REVISED STAFF REPORT AND RECOMMENDATION TO THE DESIGN COMMISSION

CASE FILE: LU 14-220722 DZ AD
PC # 14-214725
Tess O'Brien Apartments

REVIEW BY: Design Commission
WHEN: December 18, 2014 at 3:30 PM
WHERE: 1900 SW Fourth Ave., Room 2500A
Portland, OR 97201

(D) NORTH ELEVATION - OVERTON BLDG.
 1/8" = 1'-0"

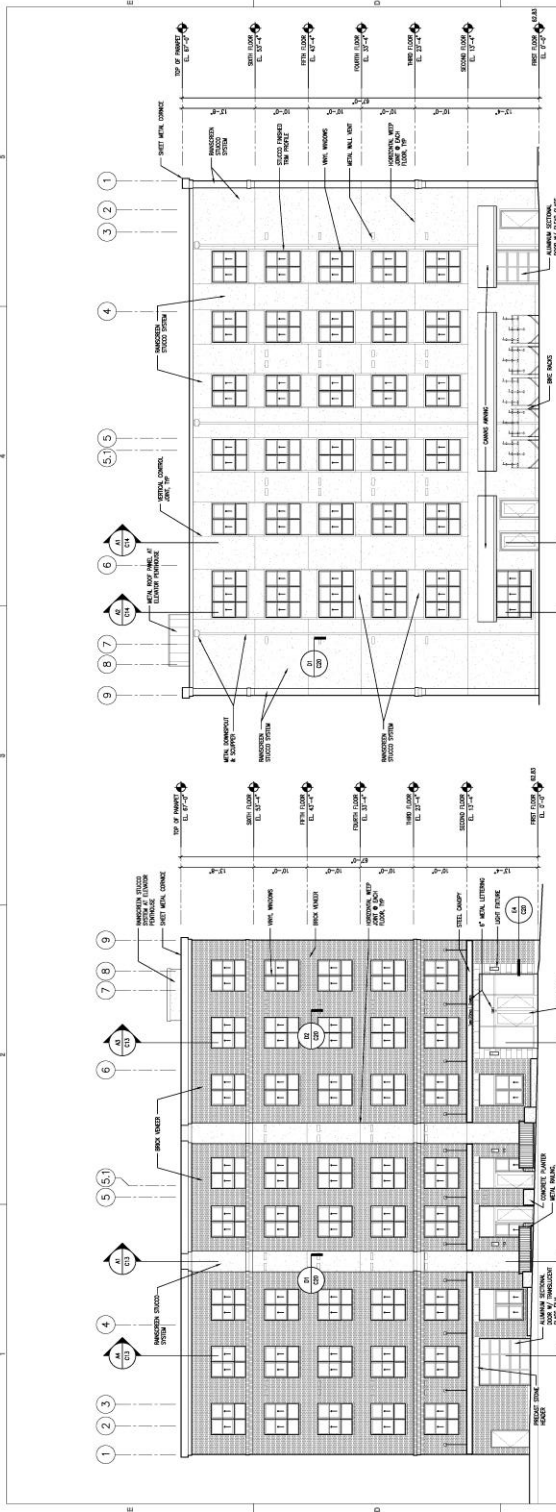
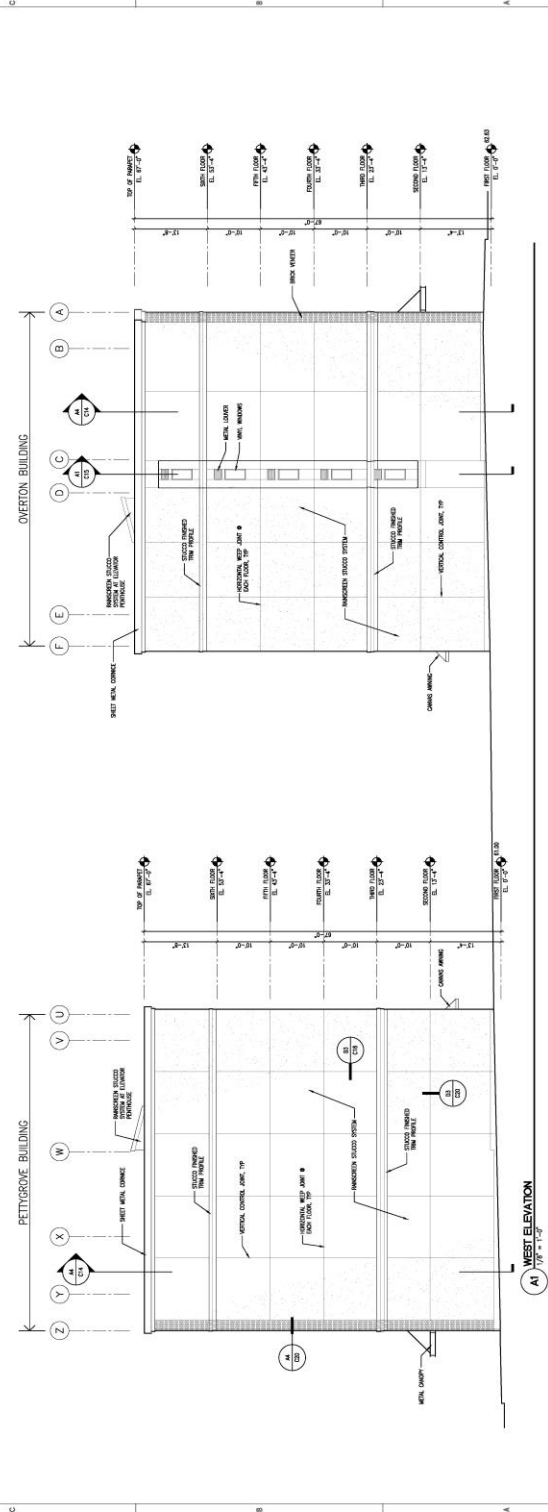
At the hearing on November 6th, the Commission indicated the buildings, each facing different streets and directions, should be differentiated to better respond to the conditions along their frontages. Both street frontages have Bike Boulevard designations with Overton as an existing bikeway and Pettygrove as a future bikeway. The Green Street designation that occurs on Pettygrove to the east is intended to be extended down along this frontage at some point in the future.

Given the similarity of the street designations, the applicant focused on the development conditions along each frontage. After further review, it was concluded that Overton consists of more low rise and town house residential scale and character, while Pettygrove hosts a modest level of retail and commercial active uses. To better respond to these different conditions revisions were made that include: a deeper street setback on the Overton frontage with four individual residential entries with porches; eliminated the street setback for the Pettygrove building and converted two ground floor residential units into one live-work unit with a storefront entry condition; and the larger Overton building street façade was revised to have an “A-B-A” composition of brick bays, in comparison to the “B-B-B” composition of brick bays on the Pettygrove street façade.

The revised concept is that together the Overton and Pettygrove buildings comprise one cohesive in-fill development, with each building’s street facing façade subtly differentiated. The differences in the façade designs are apparent on the width of the bays, but are really focused at the ground level, where the difference in conditions and uses is most obvious. *As revised, these guidelines have been met*

At the hearing on December 4th, the Commission stated the revisions were an improvement, however, larger porches and more gracious entries were needed to the ground floor units along Overton. In response, the Overton building has been setback an additional 1’ for an overall depth of 5’ from the street lot line. The 4 ground level residential units were combined into 2 larger units each with its own entry on Overton Street. Three options for the design of the residential porches have been proposed, two of which provide a 5’ x 13’ paved usable outdoor space adjacent to each entry with landscaping in a number of configurations for the remainder of the residential frontage. The applicant has stated a preference for Option A (Ex.C2.3). Staff feels that Option C (Ex. C2.4) provides the best opportunity to activate the entire residential frontage with the consideration of a potential condition to improve the entry sequence and alter the landscaping.

At the hearing on December 4th, the Majority of the Commission felt the material palette needed to be simplified and a number of combinations were discussed. In response to these comments, the fiber cement lap siding was removed completely from project and replaced with a stucco finish. Brick remains the primary material on the street facades and stucco now occurs within the recessed alcoves on the street facades and on the entirety of end and rear walls. The stucco on the rear facades is a lighter tone of the end wall color to express the interior of the “pulled apart” buildings.
